1967 Corvette: Service News: Inspection and Realignment of the Energy Absorbing Steering Column

Source: Chevrolet Service News

Date: February, 1967 - Volume 39 - Number 2

INSPECTION and REALIGNMENT of the ENERGY ABSORBING STEERING COLUMN—ALL 1967 PASSENGER CARS

1967 CORVETTE STEERING COLUMN REALIGNMENT—FIGURE 6

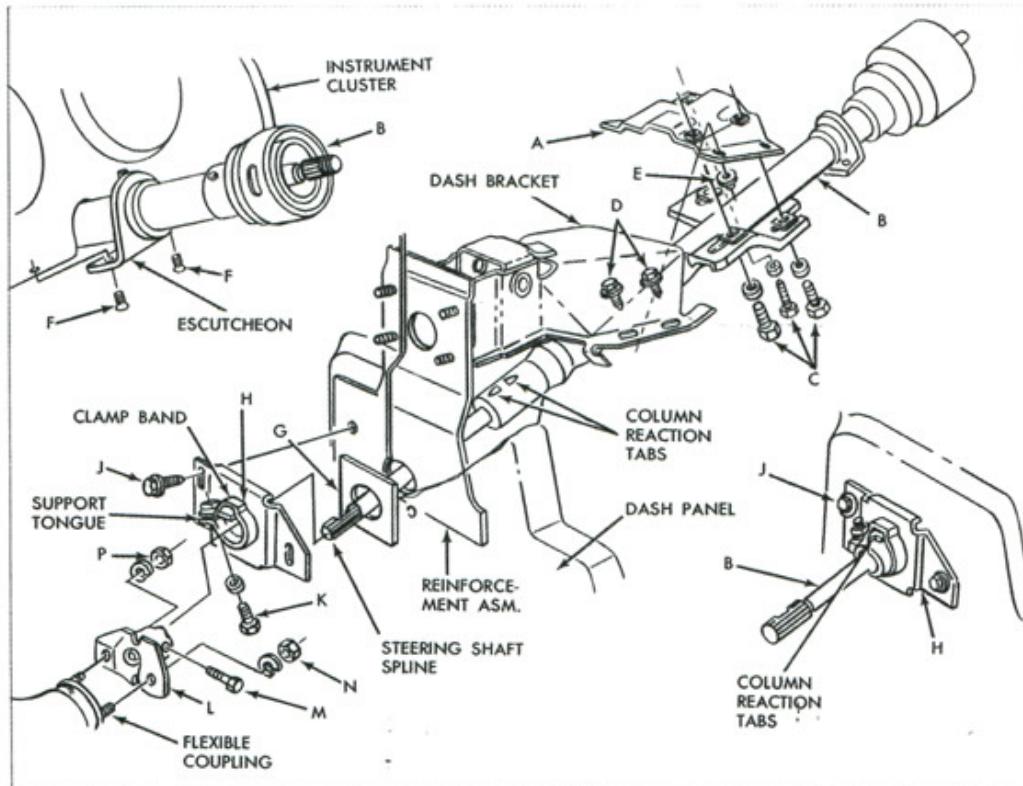
The following information on inspection and realignment of the energy absorbing steering column supplements and supersedes the information published in Section 9 of the 1967 (Passenger Car) Chassis Service Manual and the 1967 Corvair Chassis Shop Manual Supplement.

1. Loosen, but do not remove, escutcheon attaching bolts (F).
2. Loosen, but do not remove, three bolts (C) which attach the column (B) to the intermediate bracket (A). Loosen four nuts (E) and bolts (D) which attach the intermediate bracket (A) to the dash bracket.
3. Loosen bolts (J) and (K) which secure the lower column to the toe pan.
4. Loosen flexible coupling flange pinch bolt (M).
5. Check steering column to insure column is

- loose and can be moved in all directions.
6. Tighten escutcheon attachment bolts (F) to 25 in.-lbs. torque.
7. Adjust column fore or aft to place the clamp band (part of H) between the column reaction tabs (part of B).
8. With the column position defined by flexible coupling and escutcheon, hold the steering column lower support (H) against the front of dash and tighten the wrap-around clamp bolt (K) to 150 in.-lbs. torque.
9. Check bracket (H) to insure that it is not

binding against bolts (J). Tighten bolts (J) to 150 in.-lbs. torque.

10. Pull intermediate bracket (A) rearward to accommodate the height differential of the

cluster to instrument panel brace, and tighten three bolts (C) to 20 in.-lbs. torque.

11. With flexible coupling held flat, tighten upper flange pitch bolt (M) to 30 ft.-lbs. torque.
